Access Compliance Report

Public Rights-of-Way

(Curb Ramps)

Intersection ID: 14980	Main Street: DILWORTH_RD_EAST	Cross Street: EAST_BV	Location: SW
ADA ID: C266D64637C6	Ramp Type: Perp	Initial Pass/Fail: Fail	Overall Compliance: No
Severity Score: 12.5			
Codes/Mitigation Info/Possible Solution		Field Measurements/Component Compliance

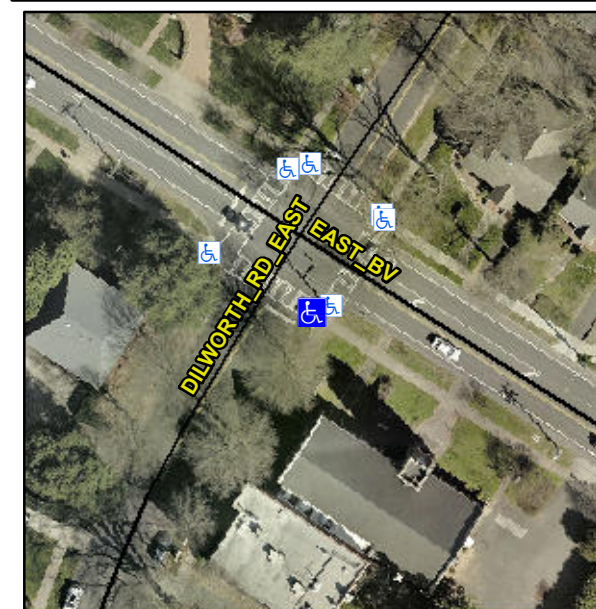
Not Found, R304.2.2

Compliance	Description	Data	Compliance	Description	Data
N/A	Ramp Length (in)	88.0	No	Ramp Slope (%)	9.3
Yes	Ramp Width (in)	73.0	Yes	Ramp XSlope (%)	0.1
N/A	Flare Type LT	N/A	N/A	Flare Type RT	N/A
N/A	Flare Slope LT (%)	N/A	N/A	Flare Slope RT (%)	N/A
N/A	Flare Traversable LT?	N/A	N/A	Flare Traversable RT?	N/A
N/A	Landing Length (in)	N/A	N/A	DWS Provided?	N/A
N/A	Landing Width (in)	N/A	N/A	DWS Contrast?	N/A
N/A	Landing Slope (%)	N/A	N/A	DWS Length (in)	N/A
N/A	Landing X Slope (%)	N/A	N/A	DWS Full Width?	N/A
N/A	Landing Curb? (Y/N)	N/A	N/A	DWS Offset (in)	N/A
N/A	Shared Landing?	N/A			
N/A	Gutter Ponding?	N/A	N/A	Gutter Slope (%)	N/A
N/A	Gutter Lip Ht (in)	N/A	N/A	Gutter X Slope (%)	N/A
N/A	Painted X Walk1?	Yes	N/A	Painted X Walk2?	N/A
	X Walk 1 Direction	To NW		X Walk 2 Direction	N/A
N/A	X Walk 1 Width (in)	110.0	N/A	X Walk 2 Width (in)	N/A
	X Walk 1 Slope (%)	6.8		X Walk 2 Slope (%)	N/A
	X Walk 1 X Slope (%)	2.5		X Walk 2 X Slope (%)	N/A

Remove & Replace Entire Ramp.
